#### MEMORANDUM

1008 Thunderbird Road

Fairlane Farms, Lot 43

The OSDS Plan for 1008 Thunderbird Road has been reviewed with the following comments:

SEPTIC SYSTEM INSTALLATION SITE PLAN

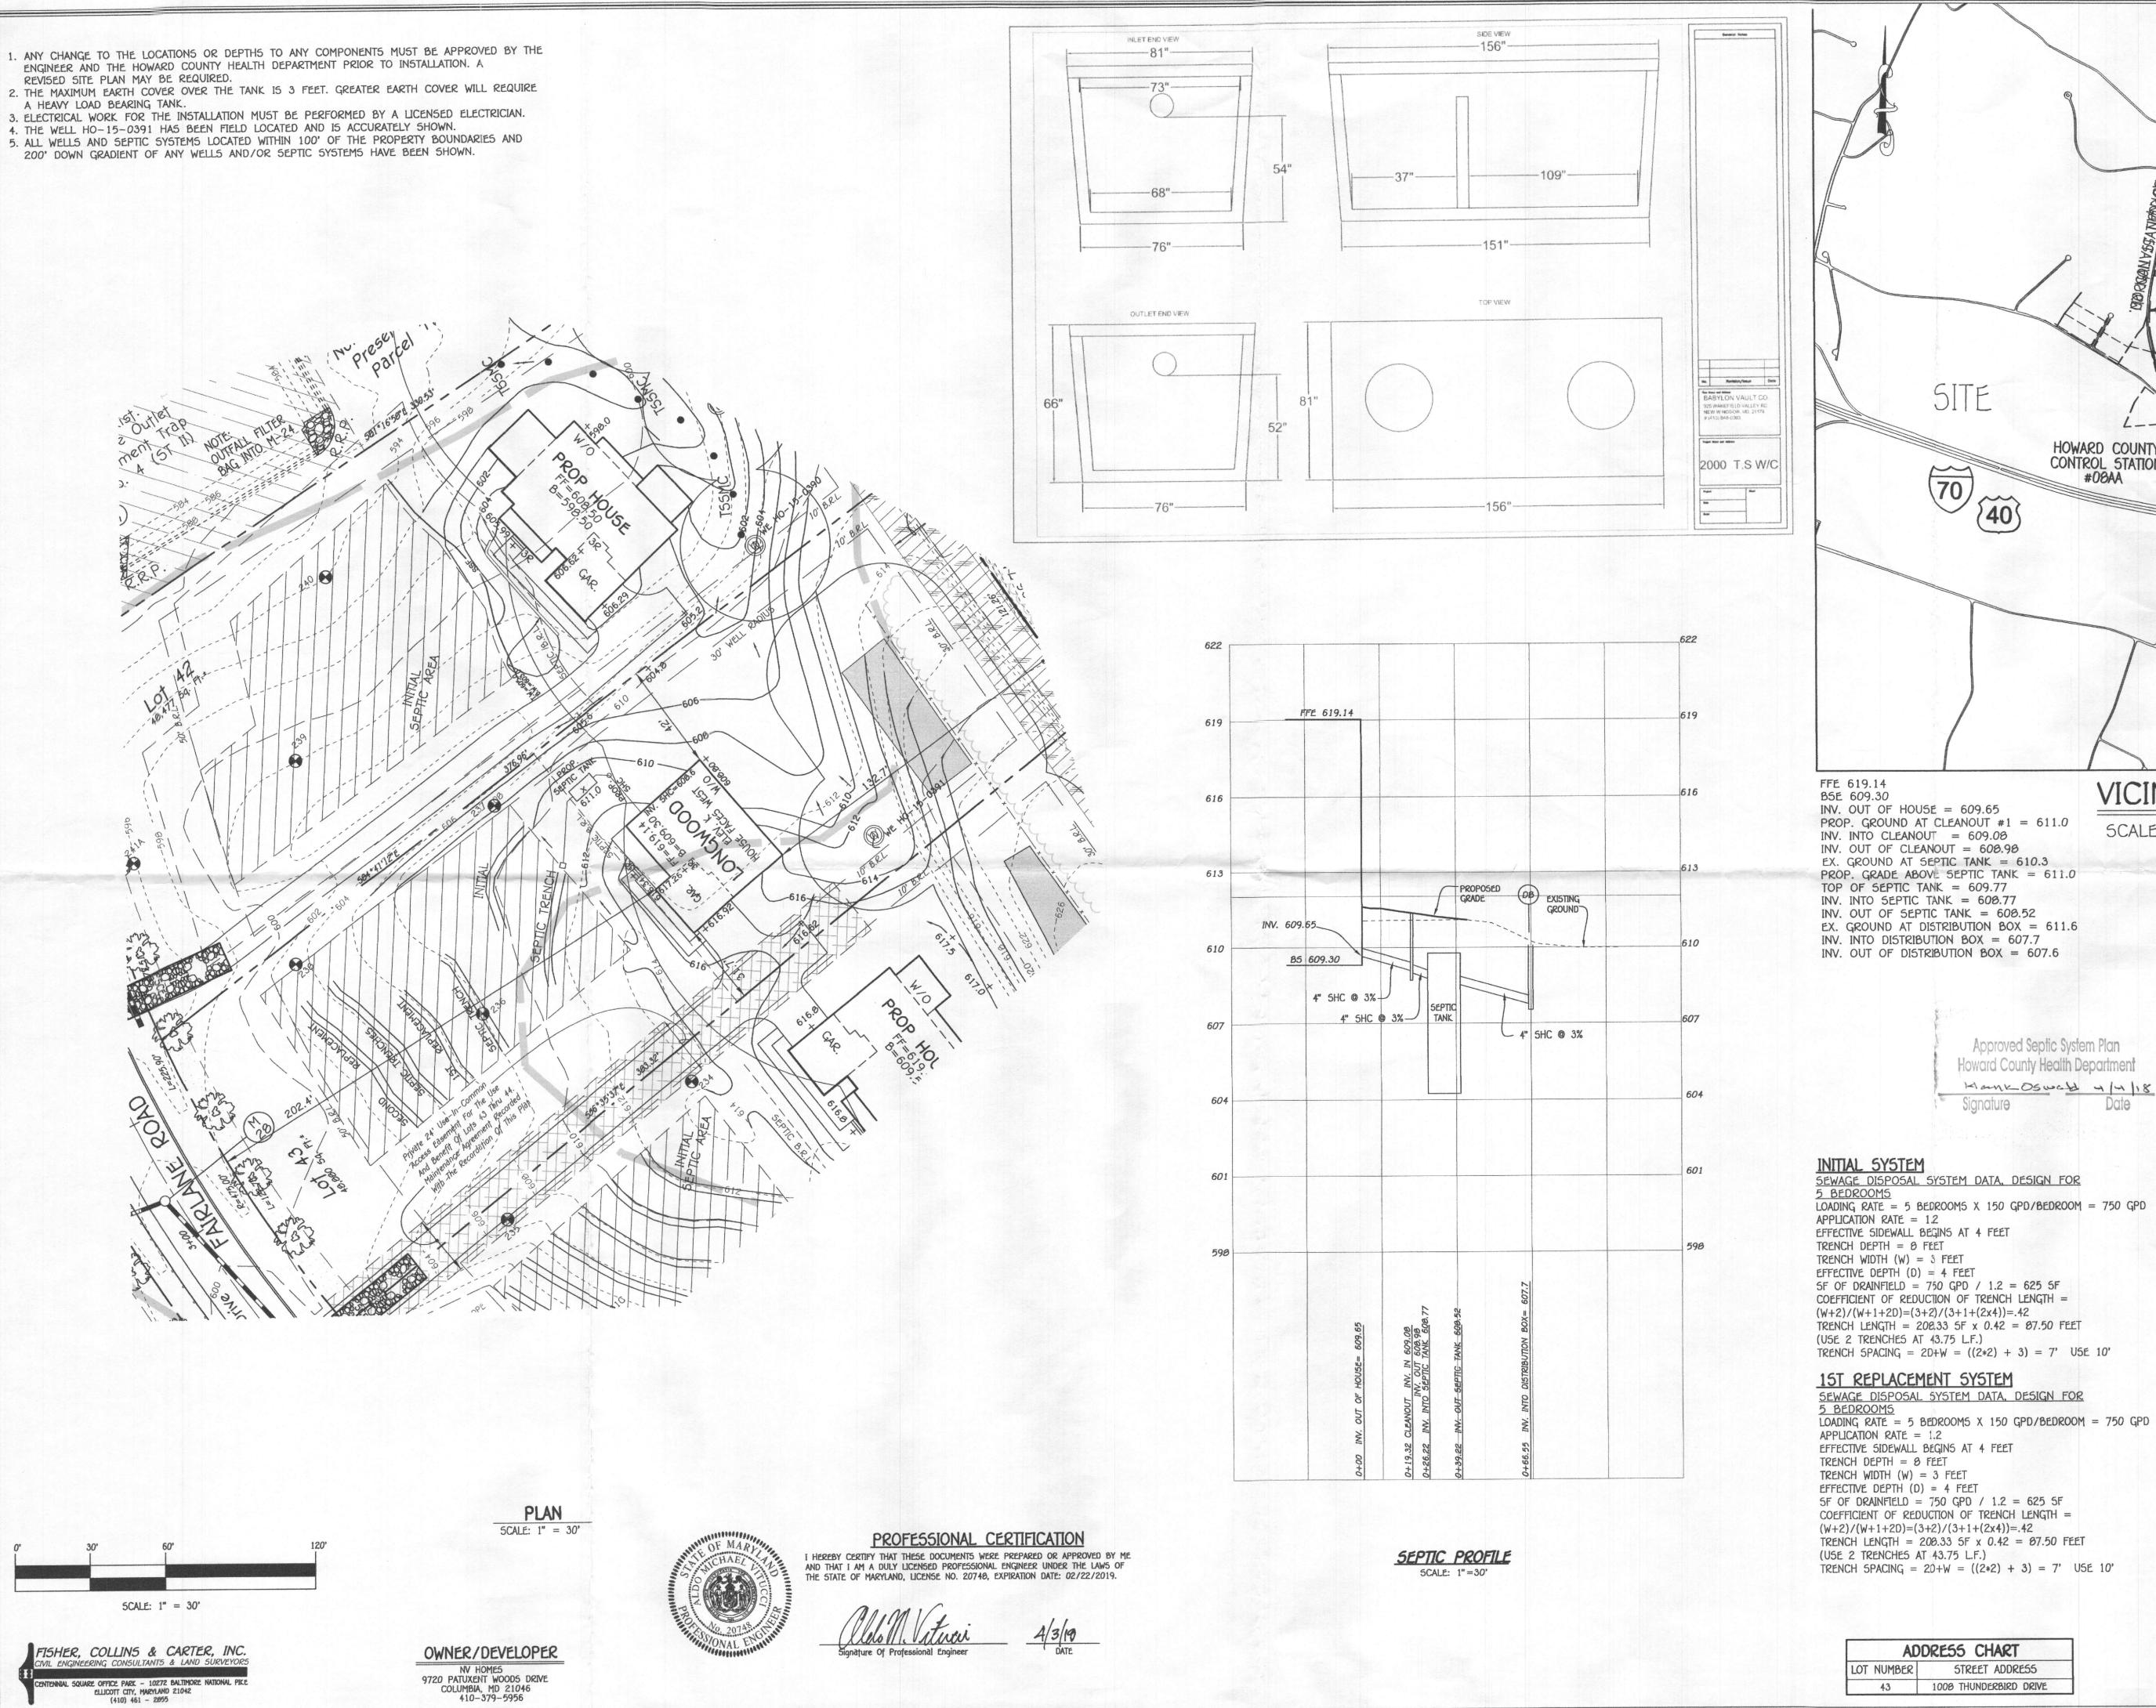
- 1.) Show all 3 systems on the plan
- 2.) Confirm basement elevation on plan (609.65 or 609.30)
- 3.) 2<sup>nd</sup> replacement system specs are 4 and 6 ft. (not 5ft and 7ft)
- 4.) Initial trench detail only shows 3.5 feet of stone and 7 foot bottom trench (It should be 4 ft. and 8 ft.).
